**General Bid Bulletin No. 6**  
November 03, 2017

**Invitation for Bid No. 17-065-3**

***Expansion of the Existing Depot at Baclaran and  
Construction of a New Satellite Depot at Zapote for  
Light Rail Transit (LRT) Line 1-South (Cavite) Extension Project***

LOW VOLTAGE SUPPLY DEMARCATION CONFIGURATION

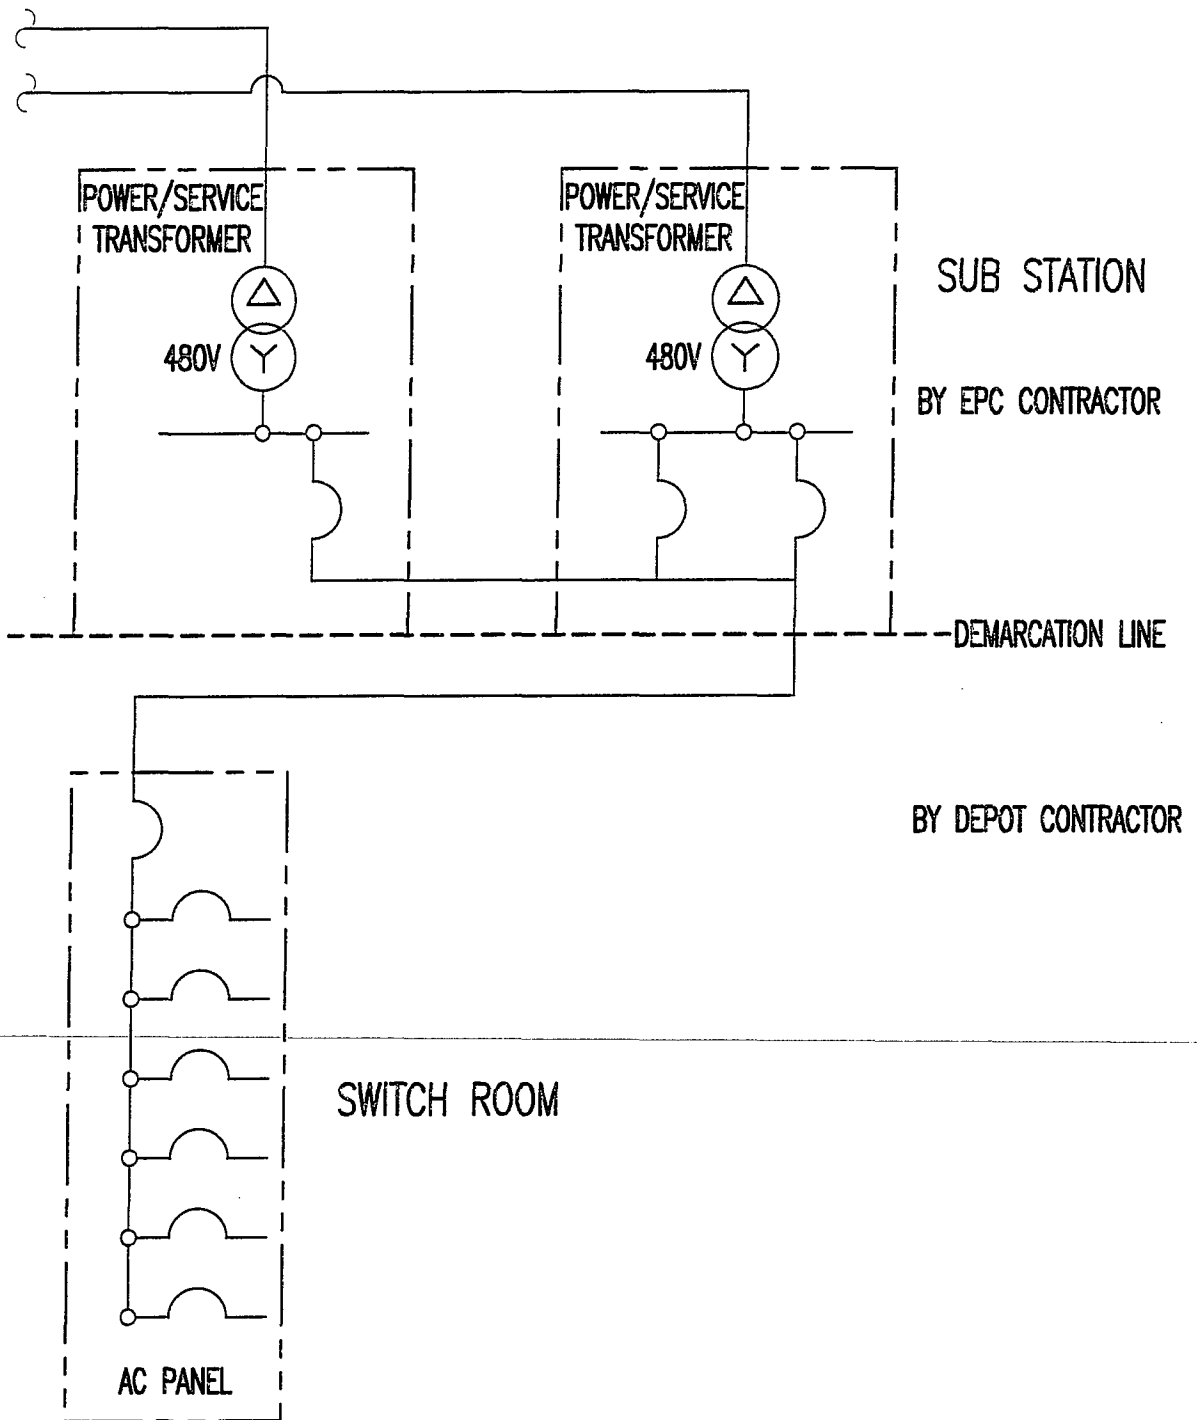
5.		Demarcation of MV & LV Scope	<p>We are still not clear on the demarcation of MV (upstream) and LV (downstream) as follows:</p> <ol style="list-style-type: none"> <li>1. Supply of MVSG is by EPC Contractor. Please confirm.</li> <li>2. Supply of transformers is by EPC contractor. Please confirm</li> </ol> <p>In your reply GBB No. 5 item no. 18 it states that "<b>Low Voltage Interface Works....</b>" which requires low voltage interface works and we are clarifying about <b>MV cables</b> and not LV cables.</p> <p>Thus, we understand that demarcation of work between EPC &amp; Depot Contractor is shown below. Termination of LV cables on the transformer shall be included in the Contractor's scope of work. Please confirm</p>	<p>Please refer attached drawing "Low Voltage Supply Demarcation Configuration"</p> <ol style="list-style-type: none"> <li>1. We confirm that Supply of Medium Voltage Switchgear is by EPC Contractor.</li> <li>2. We confirm that supply of Transformers is by EPC Contractor.</li> </ol> <p>The demarcation of work between the EPC and Depot Contractor shall be at the terminals after the main switchgear output at the substation (Clause 1.2.2 TS-170). And under clause 4.4.3 TS-6 The Contractor shall be responsible for the cable to the main isolator in the substation and feeders breaker downstream</p>

<p>located in the Switch Room. Hence the interface to the Power Supply shall be at the output on the Main Isolation Breaker. The Contractor shall be responsible for the breakers located in the Switch Room, the cables necessary to power the equipment and facilities.</p> <p>Please see attached drawing "Low Voltage Supply Demarcation Configuration" for reference.</p>
